CHANCE
MANUFACTURING CO., INC.

Service Information

Ride: SKYDIVER

Subject: CAR BODY FRAME

Rear of Car showing
Inspection Plate

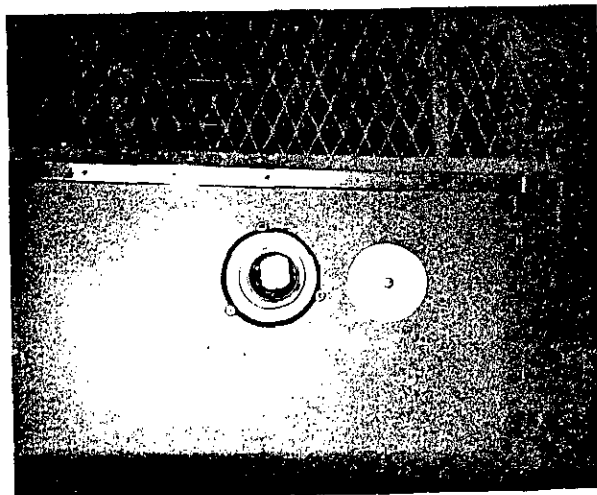
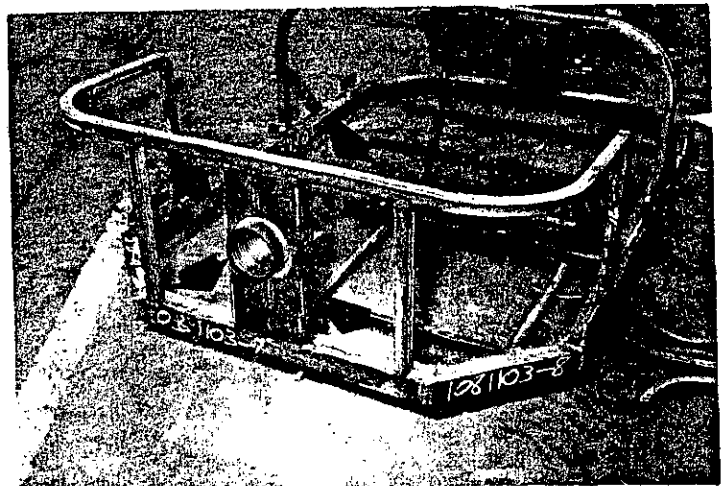
Remove the Cover Plate on the Right Rear side of the car.

Drop a small light bulb through the hole to light up the interior area for inspection.

Use an Inspection Mirror if available or rig one up using a small mirror tied on to a stick, etc.

Inspect the upper and lower tubes, especially in the area where the bearing housing channel is welded to the tubes.

If any signs of cracking are present, consult the factory for corrective action.

Inspect areas indicated
by arrows

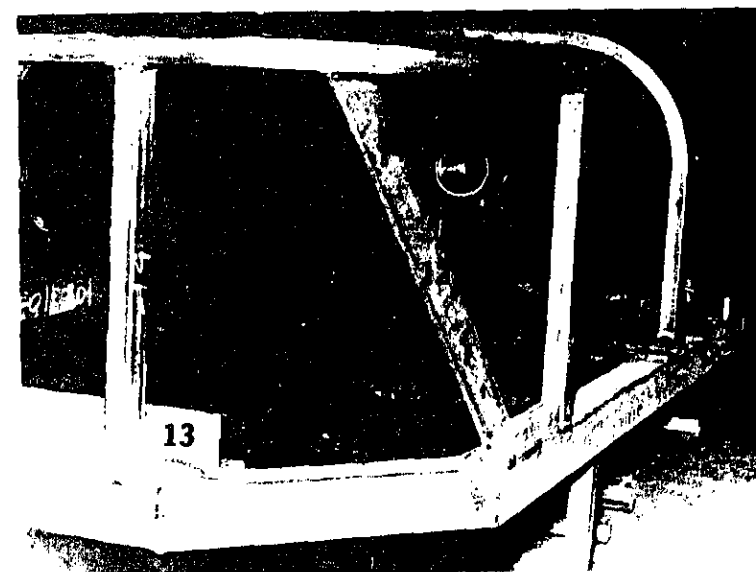
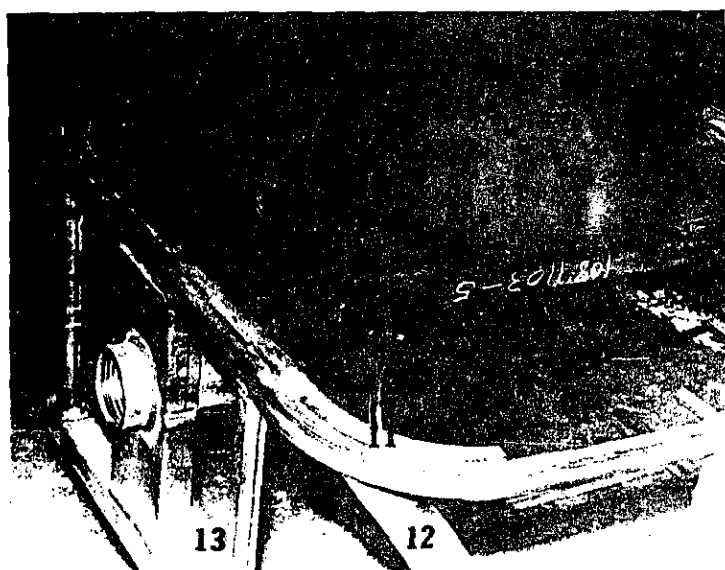
Clamp all parts before welding

FIGURE A

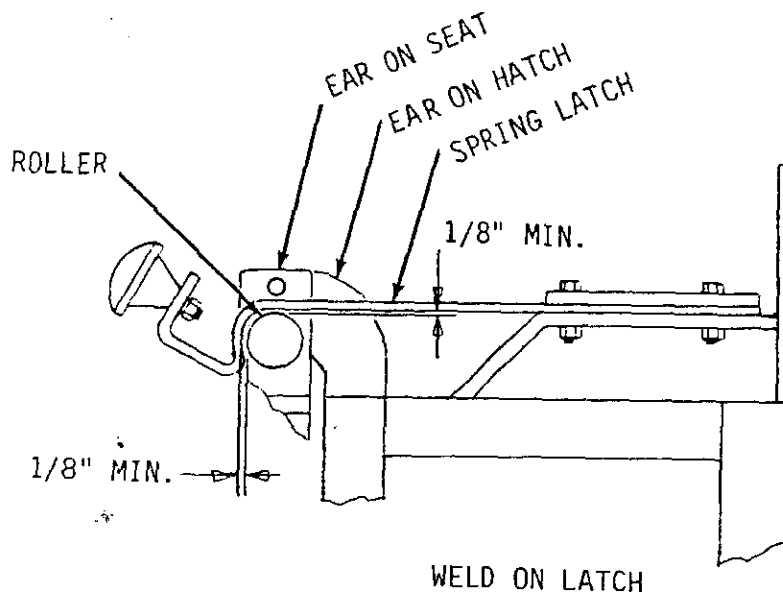
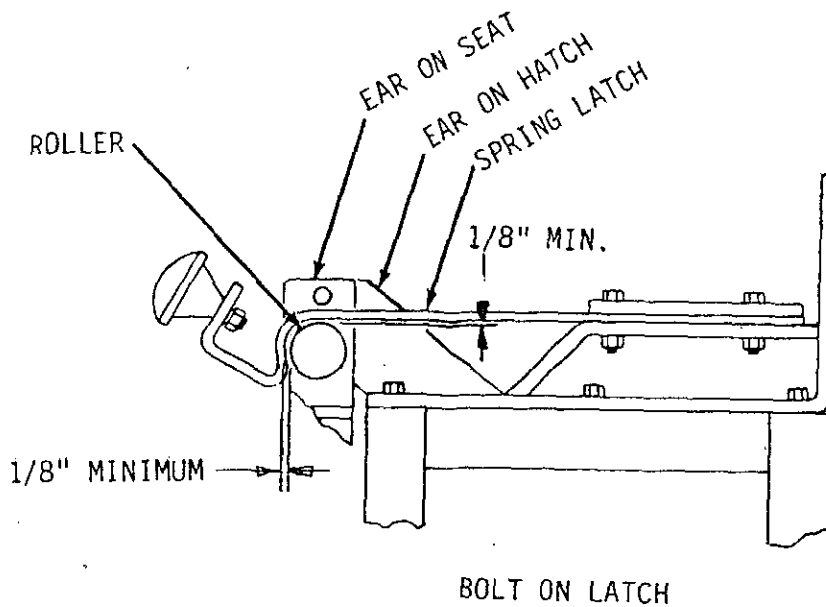
The spring latch must lie flat when the hatch is fully closed and not be forced to curve up by the height of the roller. There must be no more than 1/8" clearance between the spring latch and the roller. (See Figure A) If spring latch does not fit properly contact Chance Manufacturing Co., Inc. for proper repair procedures or replacement parts.

Do not attempt to straighten or repair the spring latch in any way. Each spring latch must be replaced annually and on or before the expiration date (month and year) etched at the knob end. Replace all spring latches that are not dated.

FIGURE B

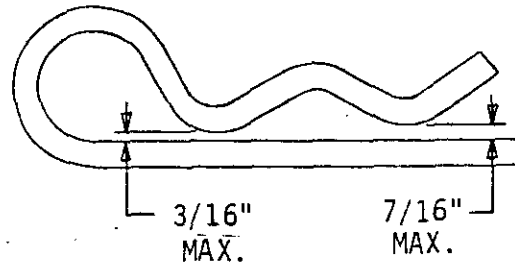
New hair pins have very minute clearance or metal to metal contact at the inner and outer lobes. Hair pins must be replaced when the clearance exceeds $3/16$ " on the inner lobe and $7/16$ " on the outer lobe. (See Figure B).

Do not use a hammer to insert or remove the hair pins. Using a hammer may cause the hairpin to turn to one side and be forced over the ear in a position where the material thickness is greater than the hair pin is designed for. This can cause the hair pin to be sprung beyond its usable dimensions.

FIGURE C

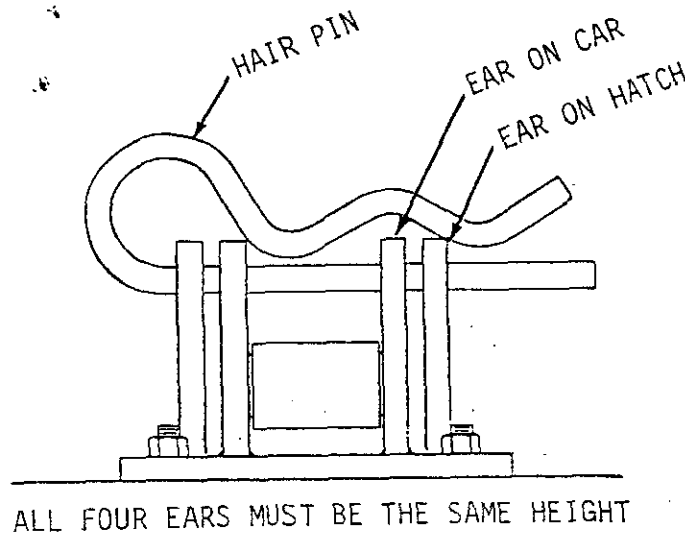
All four ears must be the same height. Under no circumstances should the outer ears be higher than the inner ears. (See Figure C).

FIGURE D

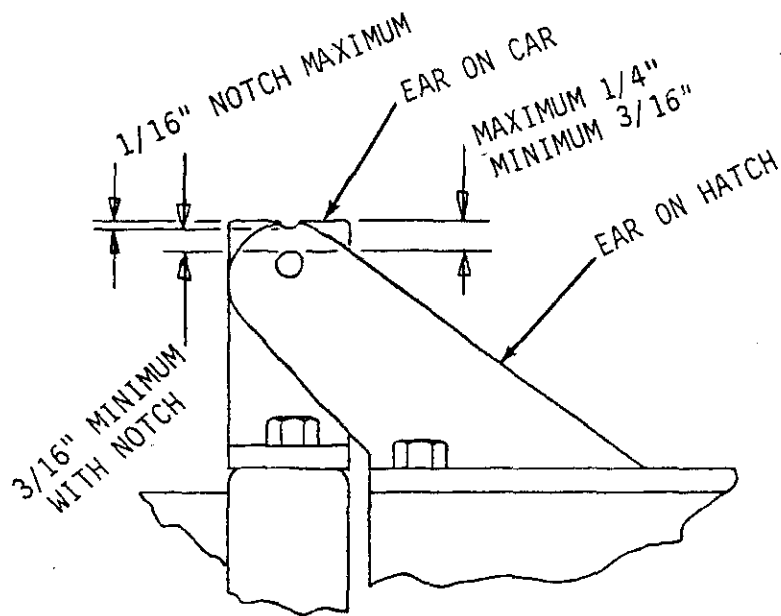
The amount of material between the top of the pin hole and the top of the ear must fall within the tolerances shown in Figure D.

If the tops of the ears become worn beyond the allowable tolerance they may be built up by welding and then ground down to the allowable tolerance.

FIGURE A

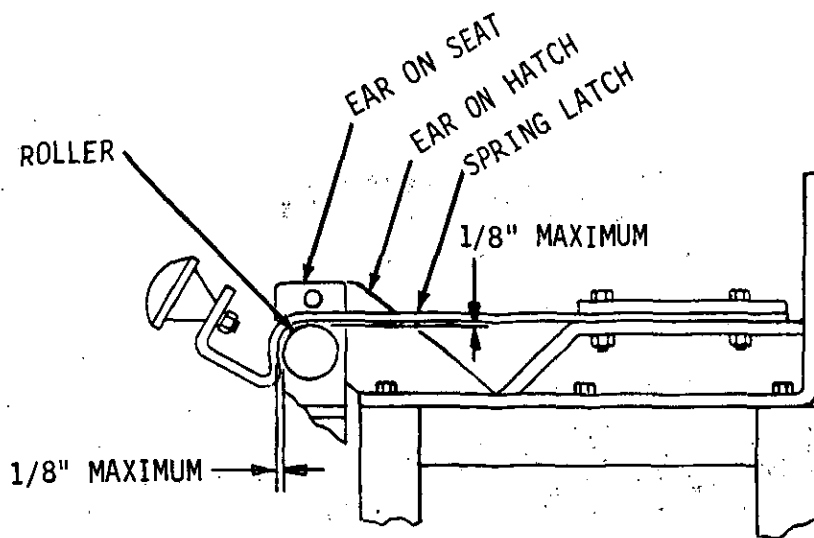
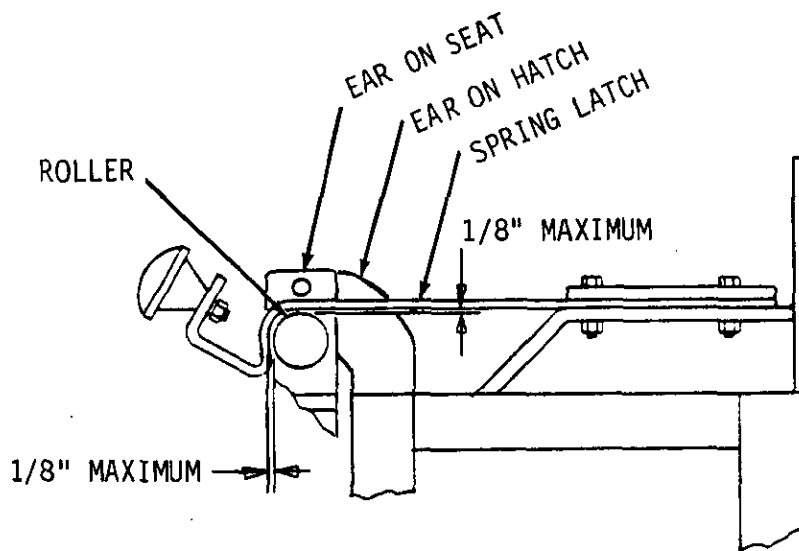
The spring latch must lie flat when the hatch is fully closed and not be forced to curve up by the height of the roller. There must be no more than 1/8" clearance between the spring latch and the roller. (See Figure A) If spring latch does not fit properly contact Chance Manufacturing Co., for proper repair procedures or replacement parts.

Do not attempt to straighten or repair the spring latch in any way. Each spring latch must be replaced annually and on or before the expiration date (month and year) etched at the knob end. Replace all spring latches that are not dated.

FIGURE B

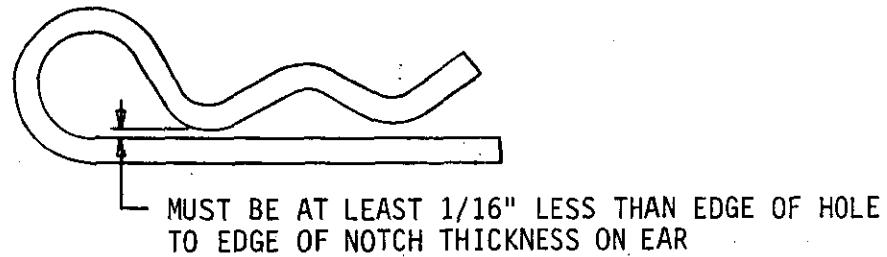
All hairpins are expendable items and will become sprung after repeated use. Clearance at the inner lobe of the hairpin, Figure B, must always be at least 1/16" less than the edge of hole to edge of ear thickness or be replaced. This ensures a reasonable amount of force (approximately 8 pounds or more) will be required to insert or remove the hairpin. A hairpin that is easily inserted and removed must not be used under any condition.

Do not use a hammer to insert or remove the hair pins. Using a hammer may cause the hairpin to turn to one side and be forced over the ear in a position where the material thickness is greater than the hair pin is designed for. This can cause the hair pin to be sprung beyond its usable dimensions.

FIGURE C

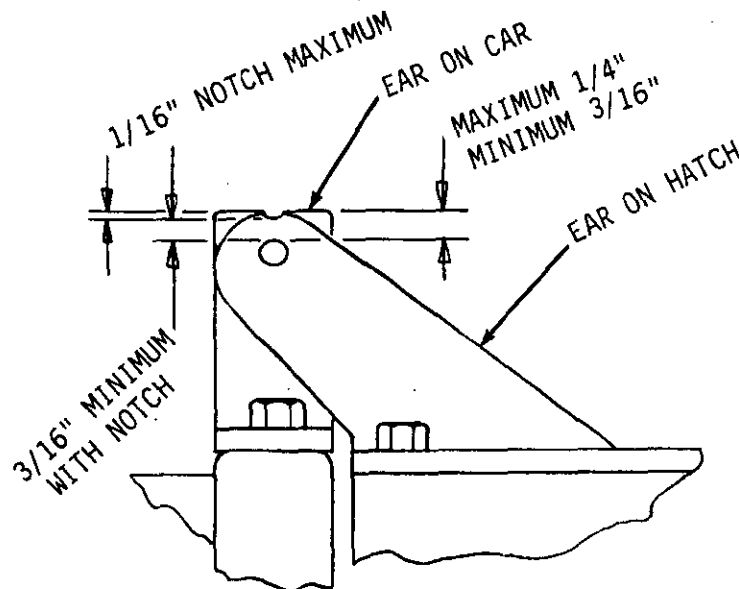
A new hairpin, inserted in a latch having maximum 1/4" edge of hole to edge of ear thickness, (See Figure C), will require the maximum force to insert and remove.

The amount of material between the top of the pin hole and the top of the ear must fall within the tolerances shown in Figure C. Replacements should be ordered for latches that cannot be maintained or repaired.

If the tops of the ears become worn beyond the allowable tolerance they may be built up by welding and then ground down to the allowable tolerance.

FIGURE D

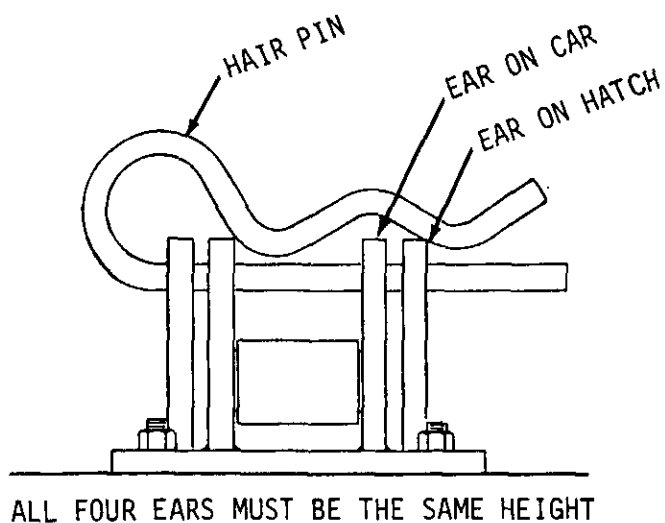
All four ears must be the same height. Under no circumstances should the outer ears be higher than the inner ears. (See Figure D).

FIGURE A

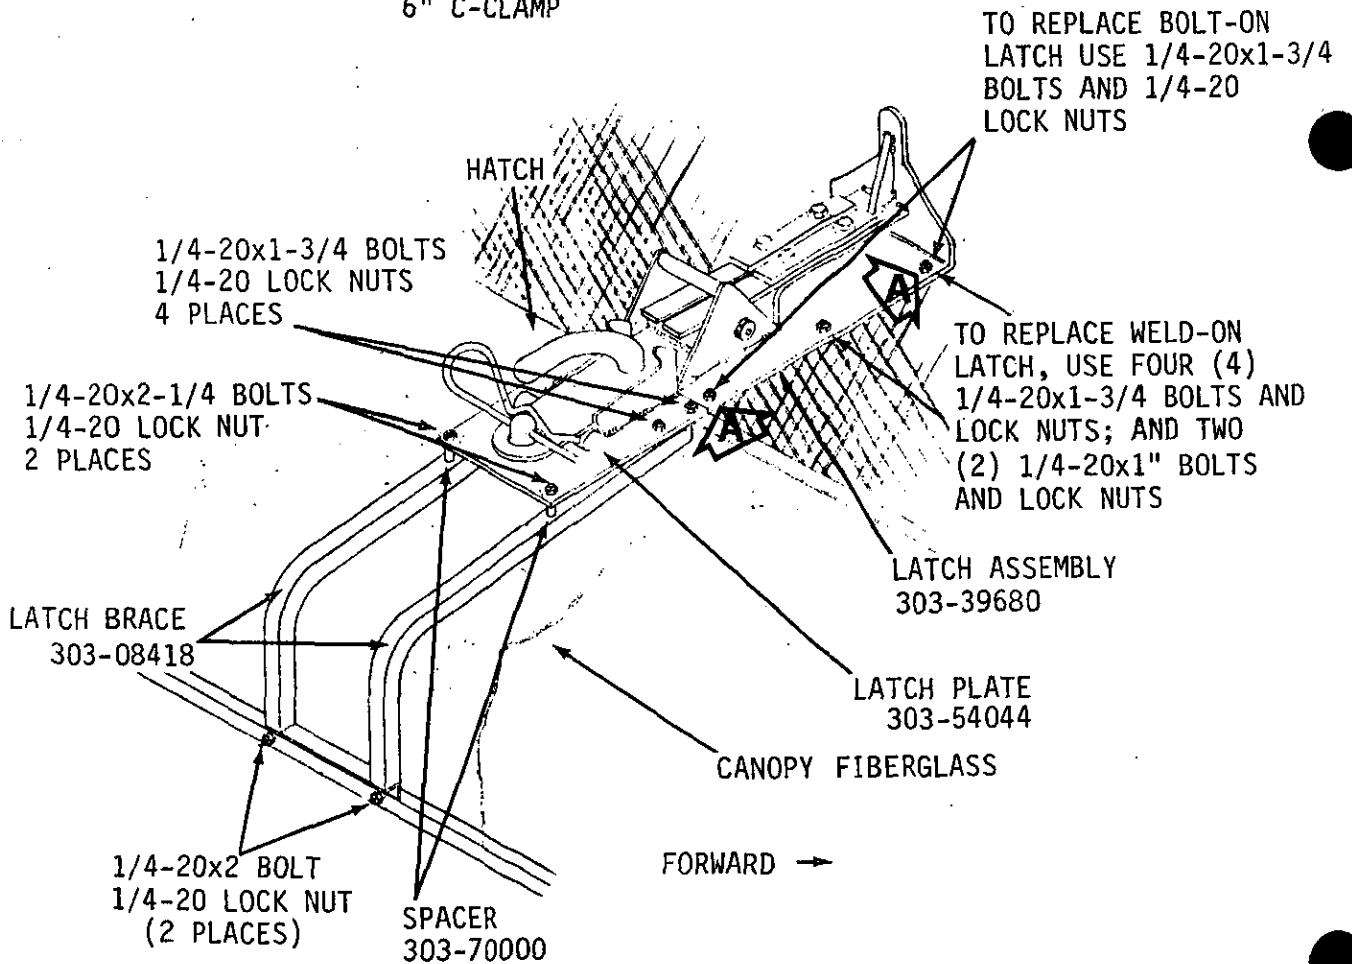
4. Use holes drilled in canopy fiberglass to align latch brace on inside of canopy as shown in Figures A and C. Using C-clamp, clamp foot of latch brace to frame tube at rear of canopy. Drill four (4) 9/32" holes in latch brace to match holes in latch plate. Install two (2) spacers between latch brace and latch plate, thru fiberglass. Secure latch brace to latch plate with two (2) Grade 5, 1/4-20x1-3/4" bolts, two (2) Grade 5, 1/4-20x2-1/4" bolts and 1/4-20 lock nuts. Heads of bolts must be on inside of car.

FIGURE B

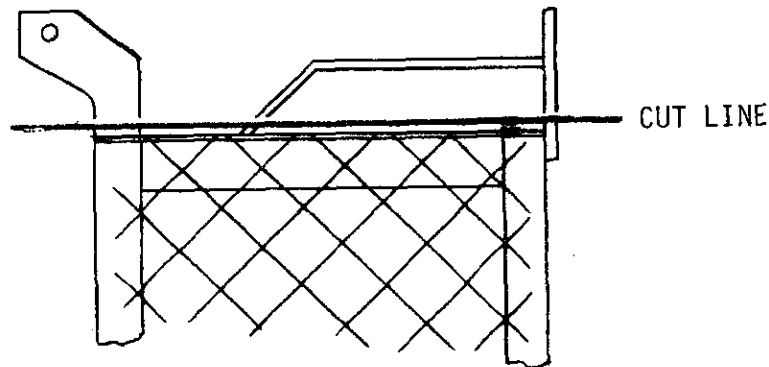
1. Weld on type (65-1202 THRU 74-1259) - Cut old latch off of hatch as shown in Figure B and grind remainder of latch level with top of screening. Position new latch assembly as shown in Figure A and drill four (4) 9/32" mounting holes through hatch frame (Arrow A): Attach latch to hatch frame using four (4) Grade 5, 1/4-20x1-3/4 bolts and 1/4-20 lock nuts. Heads of bolts must be on the inside of the car.

FIGURE C TOP VIEW

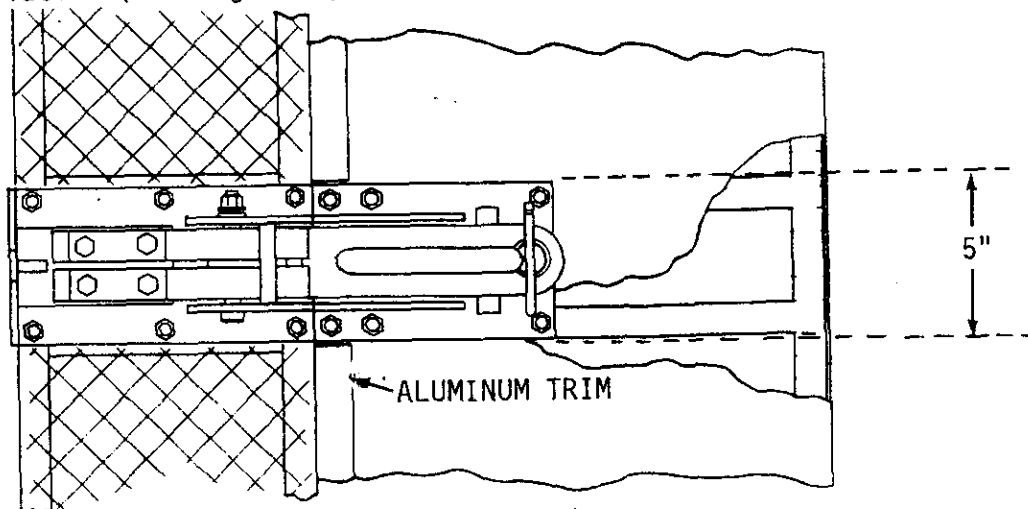
1. Remove old latch catch from canopy. Remove approximately 5" of aluminum trim with a hack saw from the canopy to clear new latch plate. (See Figure C).

FIGURE E

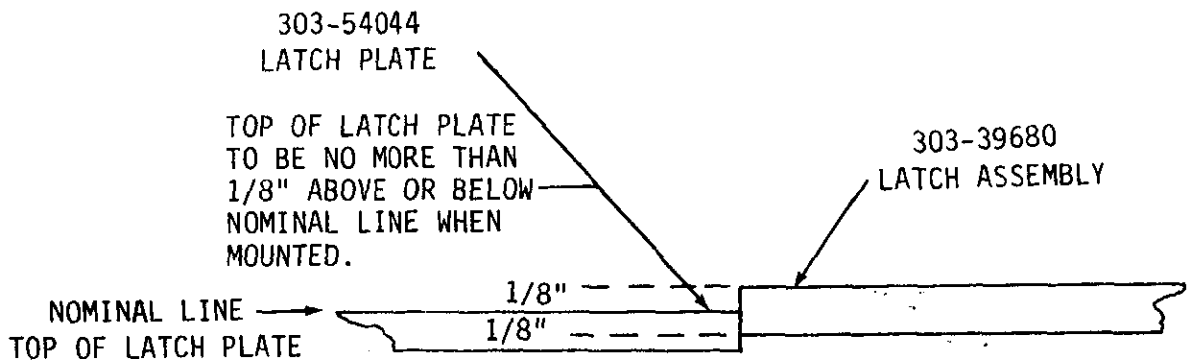
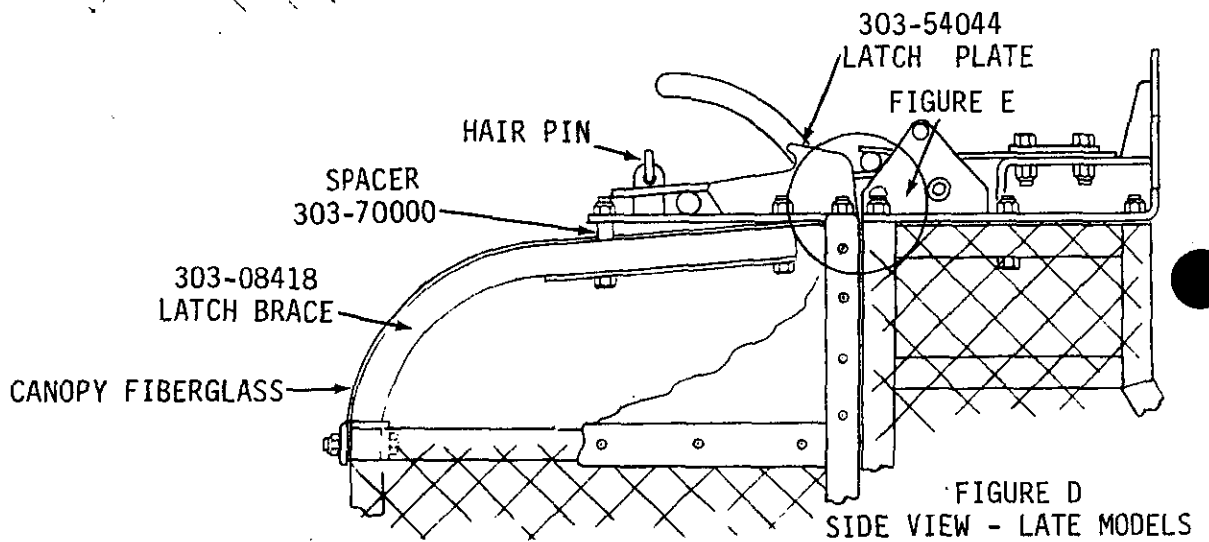
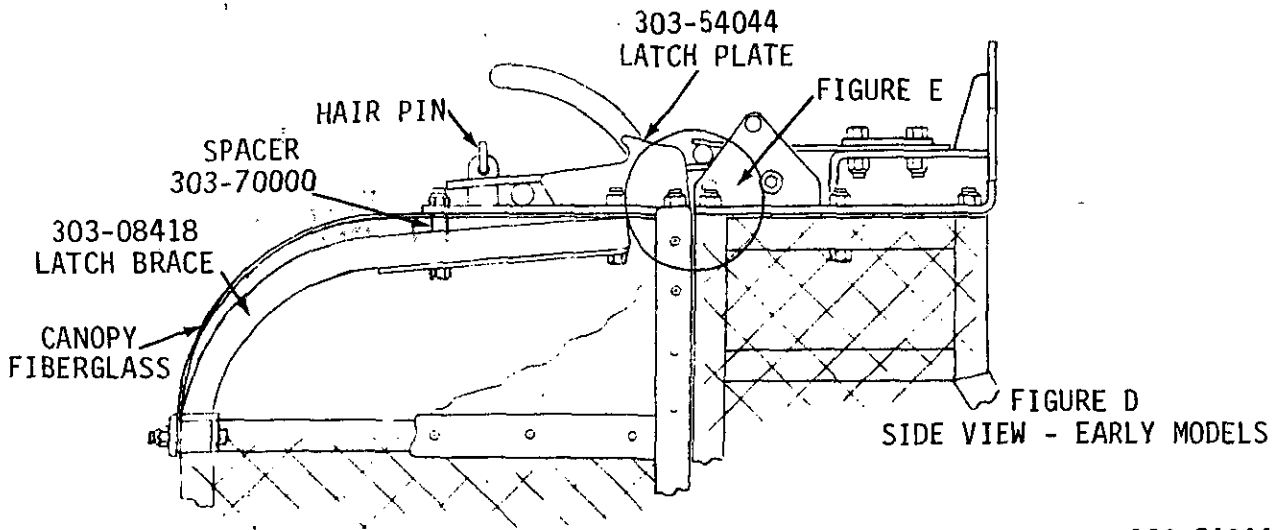
- Position latch plate on canopy and align with front half of latch assembly. Set edge of latch assembly flush with edge of canopy. Make sure alignment between the latch plate and latch assembly is as level as possible, allowing latch plate to be no more than 1/8" above or below plate of latch assembly. (See Figure E).

FIGURE A

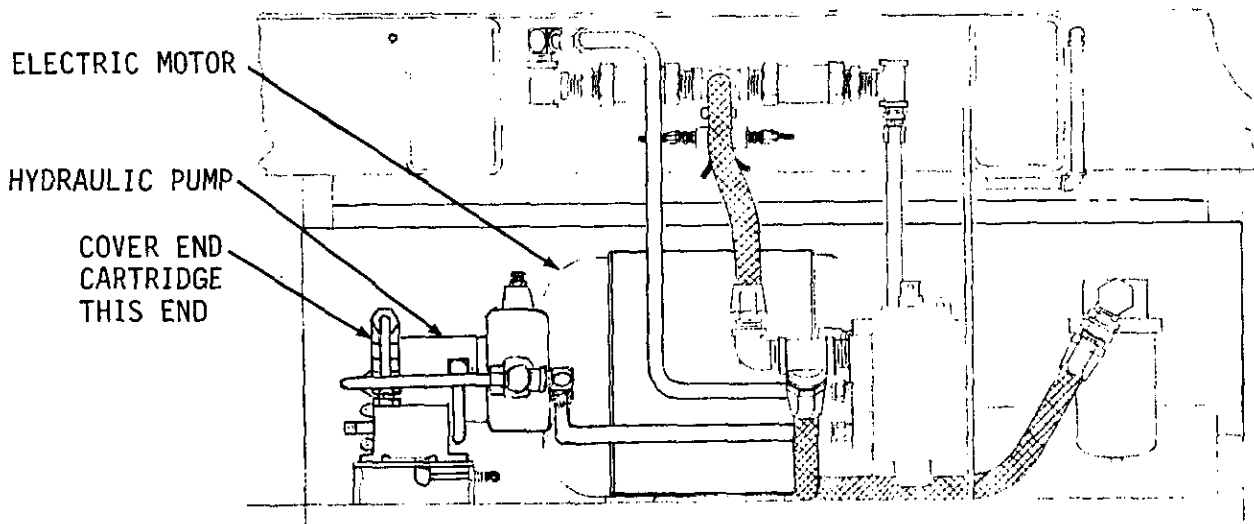
Replace the cover end pump cartridge of existing 3520V pump (located on end of electric motor with #923446 cartridge kit, following instructions given in Vickers Service Manual #M-2300-S. Restamp pump to 3520V35A8 (was previously 3520V35A11). (SEE FIGURE A)
